Notice of Intent To Grant an Exemption for the Injection of Certain Hazardous Wastes to Environmental Disposal Systems, Inc. for Two Injection Wells Located at 28470 Citrin Drive, Romulus, MI

ACTION: Notice.

SUMMARY: The United States Environmental Protection Agency, Region 5, Chicago office, proposes (through this notice) to grant an exemption from the ban on disposal of hazardous wastes through injection wells to Environmental Disposal Systems Inc. (EDS) of Birmingham, Michigan. If the exemption is granted, EDS may inject all Resource Conservation and Recovery Act (RCRA) regulated hazardous wastes through waste disposal wells #1–12 and #2–12. The regulations promulgated under the Hazardous and Solid Waste Amendments to RCRA, prohibit the injection of restricted hazardous waste into an injection well. Persons seeking an exemption from the prohibition must submit a petition demonstrating that, to a reasonable degree of certainty, there will be no migration of hazardous constituents from the injection zone for as long as the waste remains hazardous.

FIGURE 1

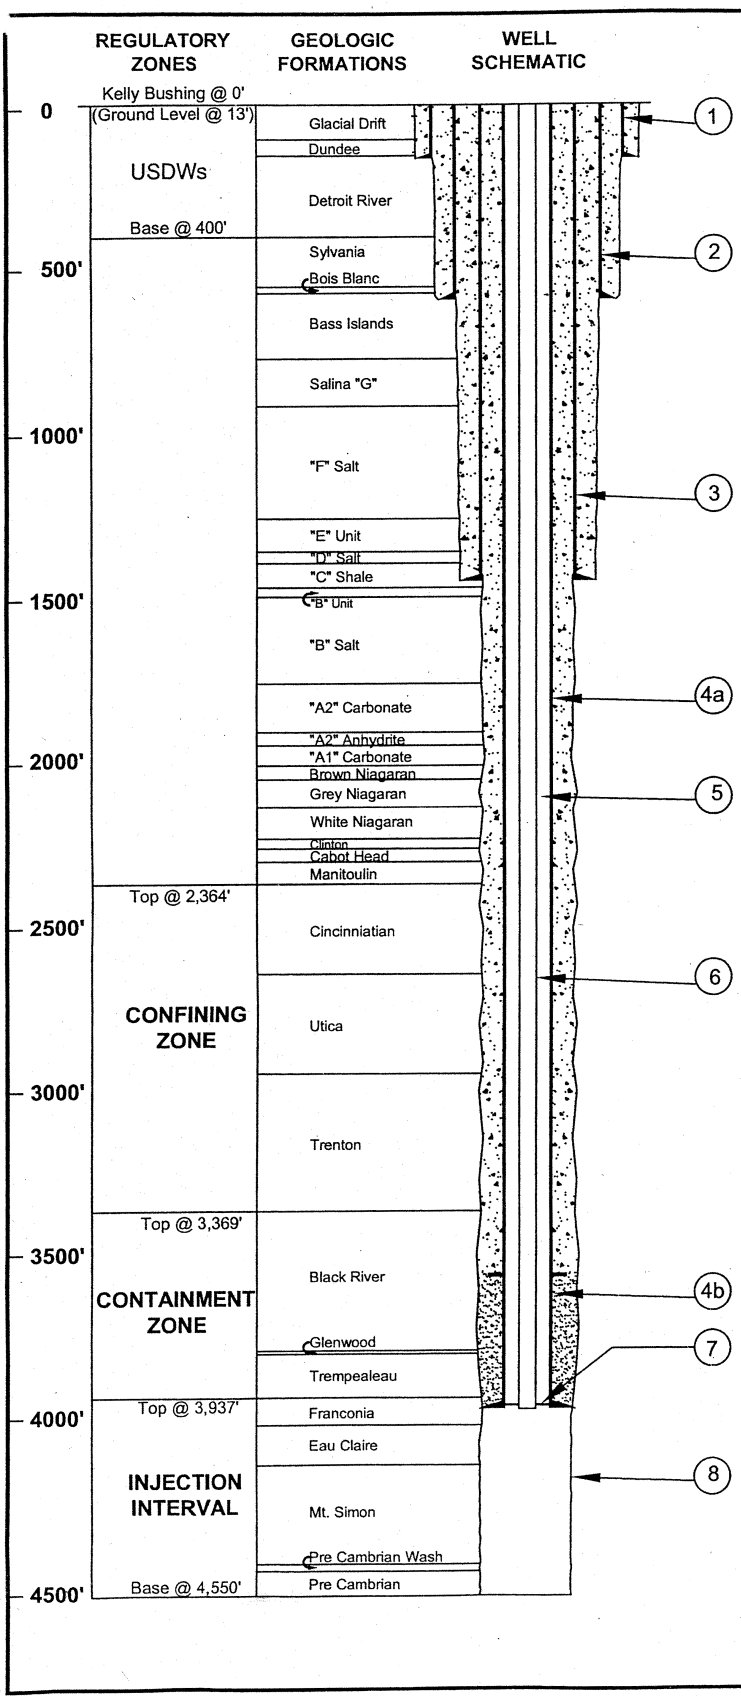
Figure 1 includes a schematic diagram of the construction of Well #2–12 and the formations penetrated by the wells. The EDS wells have been constructed using four strings of steel casing for each well. As the wells were drilled, increasingly smaller casings were placed in the well and cemented to the surface. The first cemented casings are 20 (in #1–12) and 16 (in #2–12) inches in diameter and were set at 119 and 177 feet, respectively, to stabilize the well bores through the unconsolidated glacial drift. The second strings of casing are 13⅜ inches in diameter and were set at 396 and 598 feet, respectively, to prevent loss of drilling fluid into cavernous zones in the shallow bedrock. The third strings of casing were planned to provide the safest possible conduit through the near-surface USDWs. These casings are 9⅝ inches in diameter and are set at 824 and 1444 feet, respectively. The final casing is set from the surface to within the top of the formations which will be used as the waste reservoir. These casings are 7 inches in diameter and are set at 4,080 and 3,983 feet, respectively. The space around each of the casings was sealed with cement from the base of the casing to the surface. Cementing eliminates potential avenues for either the injected fluid or fluid from other, shallower zones to flow outside the casings and into USDWs.

EDS will inject the waste through a tubing set on a packer and isolated from the casing by a fluid-filled annulus, which will be continuously monitored for pressure change. The monitoring system is designed to trigger alarms and shut off injection if the injection pressure exceeds the maximum permitted levels, or if the difference between the injection and annulus pressures falls below the minimum permitted level.

Thus, the integrity of the construction will be monitored constantly by measuring the pressure within the annulus between the casings and tubing and tracking the amounts of liquid added to or removed from the annulus system. Even a small leak should be detected before environmental injury occurs. More rigorous annual testing ensures that even very small leaks are discovered. The pressure in the annulus will be maintained at a higher level than the pressures in either the formations outside the casing or within the injection tubing. Therefore, even if a leak occurs, the waste will not leak into the annulus; instead, annulus fluid will leak into the injection tubing through which waste is being injected and be carried downward into the waste disposal reservoir or, in the case of a casing leak, annulus fluid, not waste, will leak into the formations surrounding the well.

As described, the construction provides for a replaceable tubing and a system to detect when replacement of the tubing is necessary. The tubing prevents the waste from contacting all except the lowermost few tens of feet of casing, which are made of a corrosion resistant alloy. The three casing strings and layers of cement through the fresh water bearing formations provide extra protection from contamination.
